# SERVICE BULLETIN

FUJI HEAVY INDUSTRIES LTD.

NO : FAS-060

1. SUBJECT : Staking of Heads of Screws Holding Upper Piston Stopper Plate, Nose Landing Gear.
2. AIRCRAFT AFFECTED: FA-200 Series, Serial Nos. 2 thru 55.
3. PRIORITY : Essential.
4. REASON : To prevent possible loosening of the subject screws.
5. DESCRIPTION : Retighten the six attaching screws, and one point stake each head of the screws.
6. ACCOMPLISHMENT : Immediately upon receipt of this publication.
7. APPROVAL : JCAB Approval (NO-TOKYO-039) January 24, 1972.
8. PART REQUIRED : The following parts will be furnished free of charge to owners of the affected aircraft.

FIGURE 1. ILLUSTRATION OF PUNCH STAKING

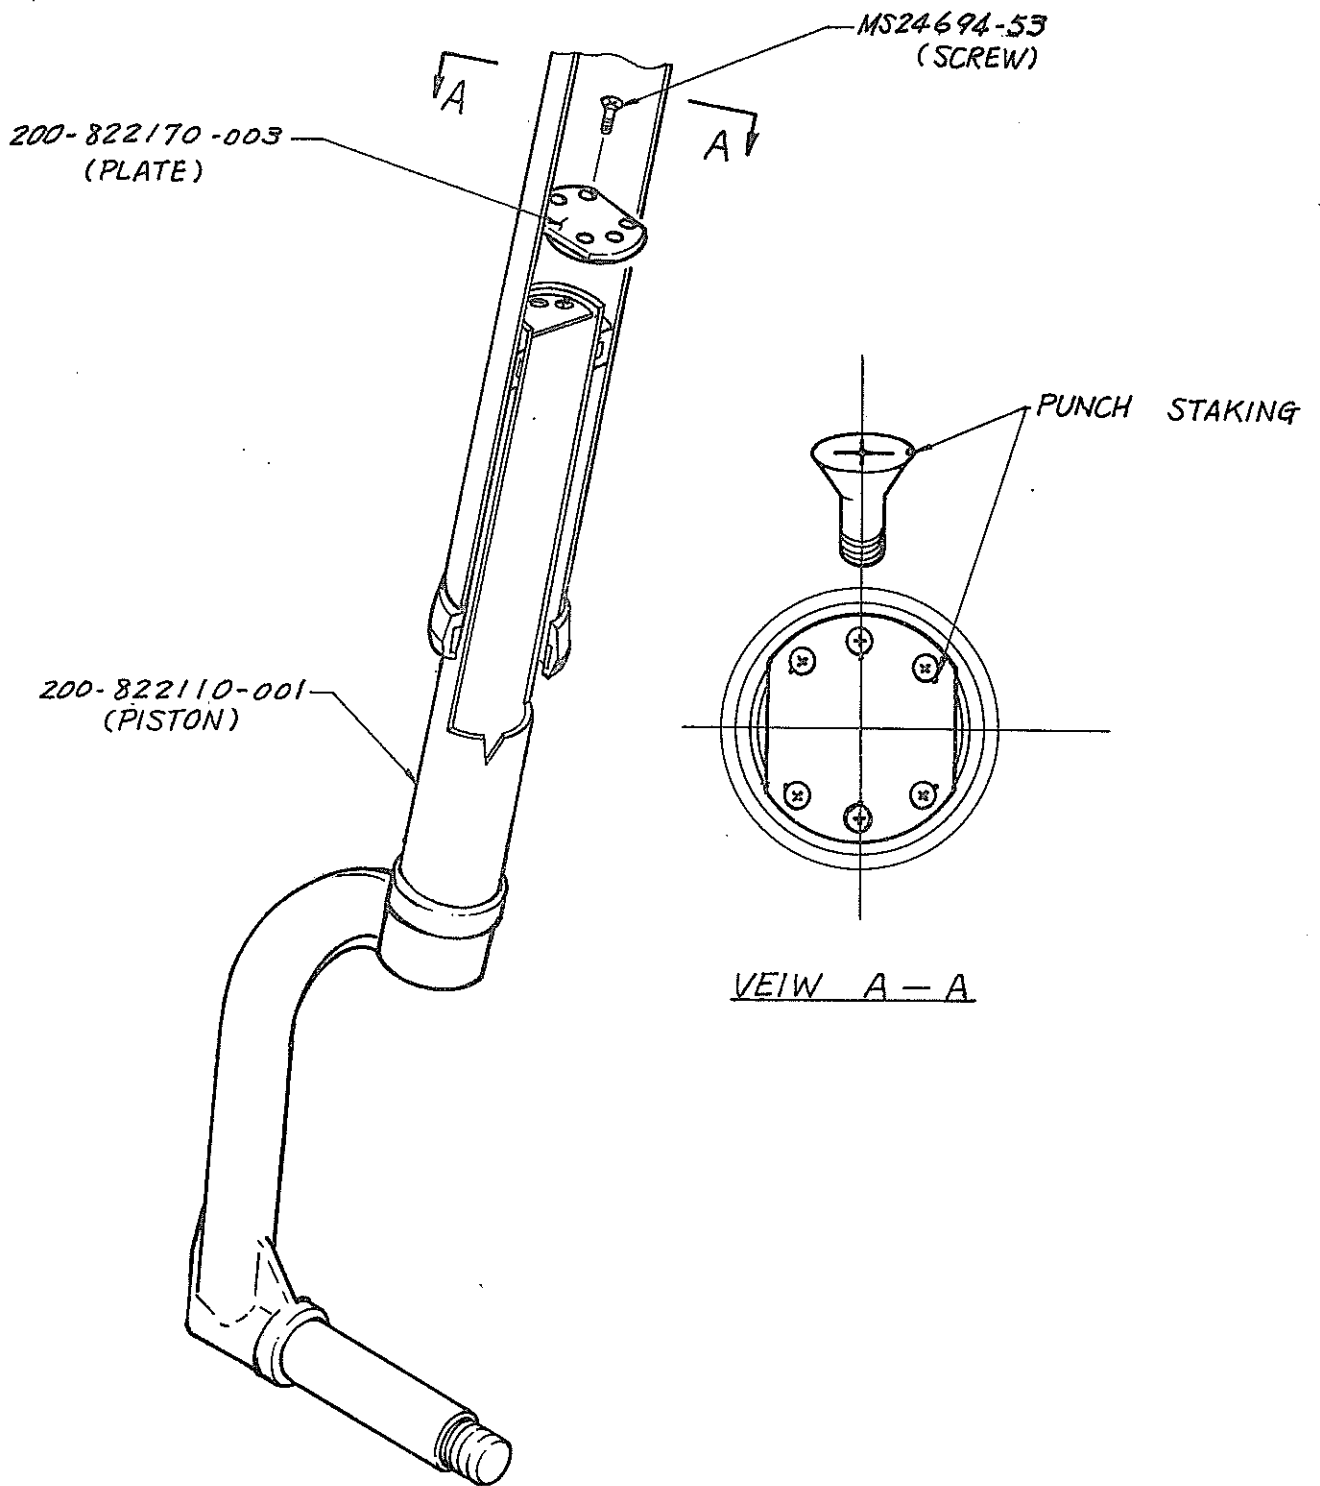
3. Compress the piston 200-822110-001 to the full.
  4. Using the special screw driver, check the six attaching screws MS24694-53 for looseness (Refer to figure 1).

5. After completion of the above check, retighten the six attaching screws with 20 in-lbs torque, and then, one point stake each screw head as illustrated in figure 1.

FIGURE 2. ILLUSTRATION OF SPECIAL TOOL

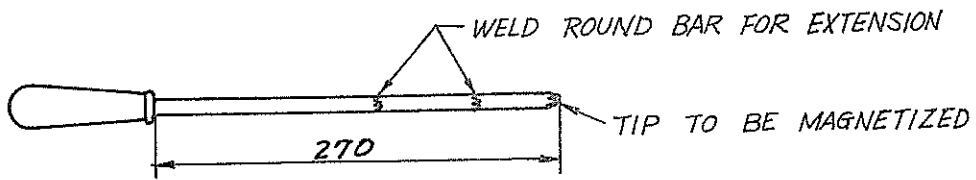
9. SPECIAL TOOL : Punch and Special Cross Point Screw Driver (are shown in figure 2 and may be fabricated locally).
10. WEIGHT AND BALANCE : No change.
11. REFERENCE : Not applicable.
